TEXAS UTILITIES SERVICES INC.
COMANCHE PEAK STEAM ELECTRIC STATION
LIMITS 1 & 2

DELAVAL TURBINE INC.
DELAVAL TURBINE AND
COMPRESSOR DIVISION
OAKLAND CALIF 94612

CONTROL PANEL SCHEMATIC

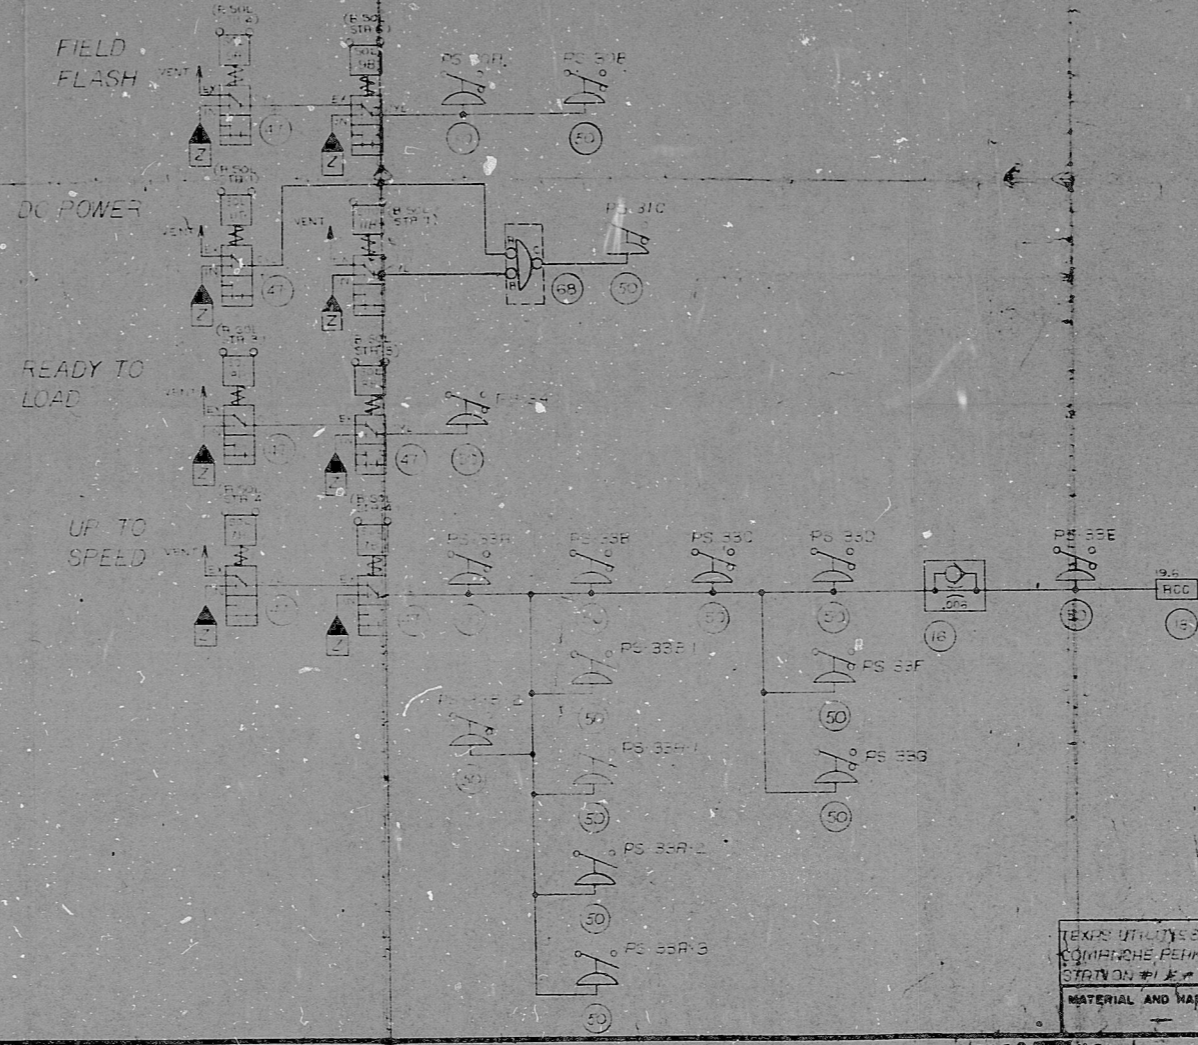
APPROVED
FOR ARRANGEMENT ONLY
PROJECTS WITH FURNISHING
SUBJECT TO COMPLIANCE WITH
ALL SPECIFICATIONS AND
REVISIONS AND TYPICALS
APR 18 1980
CROSS & MILL, INC.
ENGINEER, RESERVE DIVISION
NEW YORK
